## **ADDENDUM TO INITIAL STUDY/MITIGATED NEGATIVE DECLARATION ER 98-01**

1. **Project Title:** Bob Jones City-to-Sea Bikeway Project
2. **Lead Agency Name and Address:**  
City of San Luis Obispo  
919 Palm Street  
San Luis Obispo, CA 93401

3. **Contact Person and Phone Number:**  
Greg Cruce, Deputy Director of Maintenance Operations  
gcruce@slocity.org  
(805) 781-7264
4. **Project Location:** Bob Jones City-to-Sea Bikeway, Segment 3 (Prado Road to Los Osos Valley Road), within the City of San Luis Obispo.

8. **Description of the Project:**  
The proposed project consists of the replacement of approximately 0.75 mile of existing fencing located along the Segment 3 of the Bob Jones City-to-Sea Bikeway (also known as the Bob Jones Trail) to enhance public safety and provide additional protections to San Luis Obispo creek (the "Project"). The existing split-rail fence would be replaced by a five-foot tall wood fence including six by six posts, three-rail (horizontal) design, to be reinforced with PVC-coated chain link fence on the side of the fence facing the creek. The existing security fence located between the trail and the City's Water Resource Reclamation Facility (WRRF) w

**A Bikeway Fencing Examples**

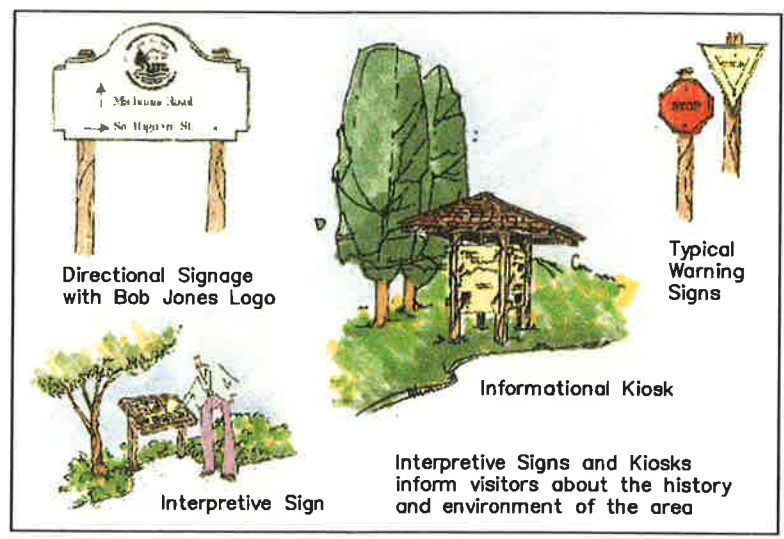
Preliminary Alignment Segment 3 – Sheet 4, shows trail fencing options including wood with 4-strand wire or split rail fence (both four feet in height). The adopted MND for the Bob Jones Trail including all four segments identified potential significant, but mitigable to less than significant, impacts in the following issue areas: agricultural resources, biological resources, cultural resources, hazards and hazardous materials, hydrology/water quality, and transportation traffic.

The project includes removal of the existing three-foot tall, split-rail fence. The Project's proposed fence would be constructed within the same alignment as the existing fence. The trail itself would continue to be used the same as current conditions. The modification to the fence would not result in any new impacts that were not previously disclosed in the adopted MND, or result in an increase in the severity of a previously identified impact. Additional discussion is provided below.
